JUST THE FACTS

High-Temperature Blower Motor Resistor Connectors

i Solution: Improved design for S3066HT

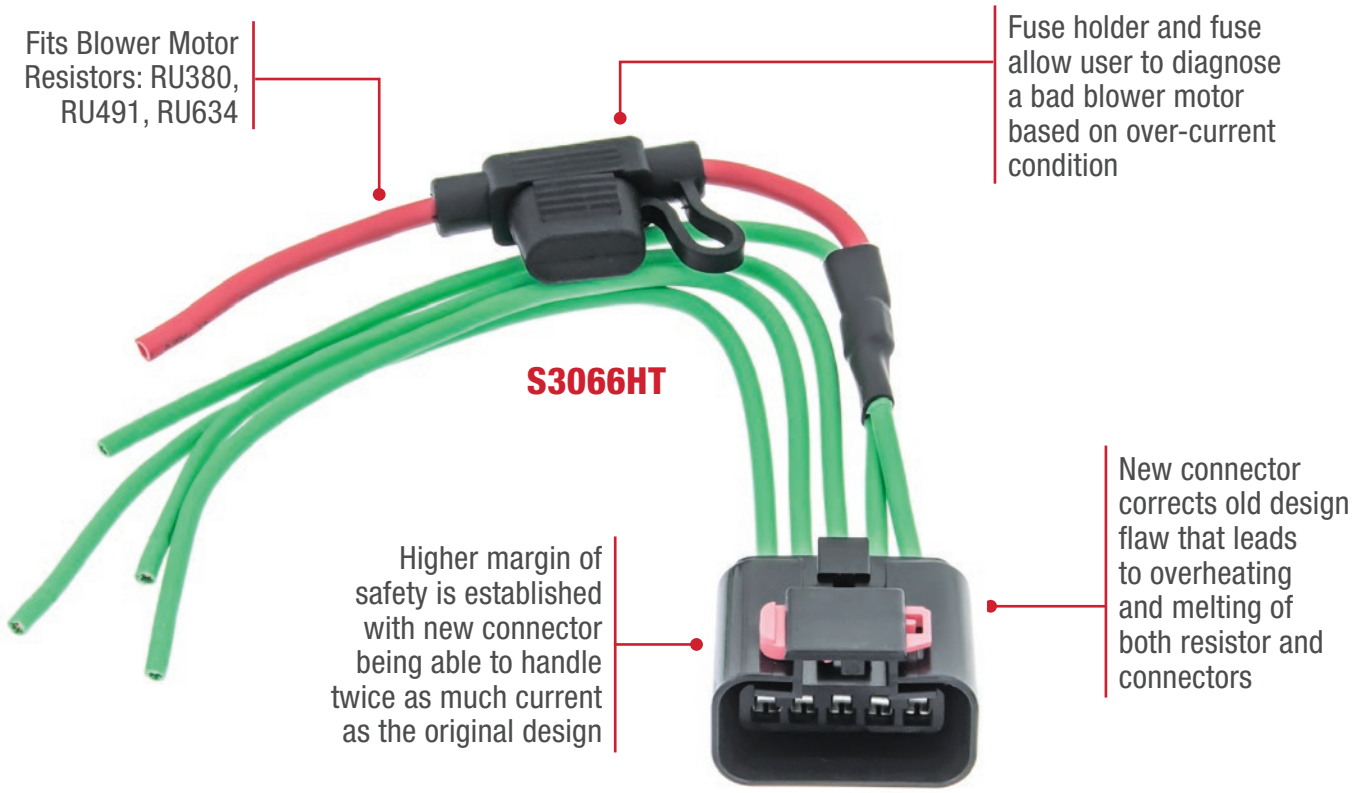
! Problem

Due to technological advancements in today's automotive heating and cooling systems, blower motor resistors have high amounts of current running through their connectors. As a result, the current produces heat that can melt the connector and resistor.
